Product Change Notification: E-15-003448 PCN Date: 04-MAR-15

040III TAB CONTACT 353537-1 and 353537-2.

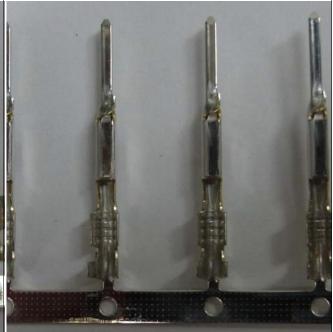
PN 353537-1 and 353537-2; Carrier area; Additional 1.5mm*5.5mm Punched Hole per 9.5 mm pitch. The crimping report will be released by Mar 20. If you have any question, please contact Ken Sakai san.
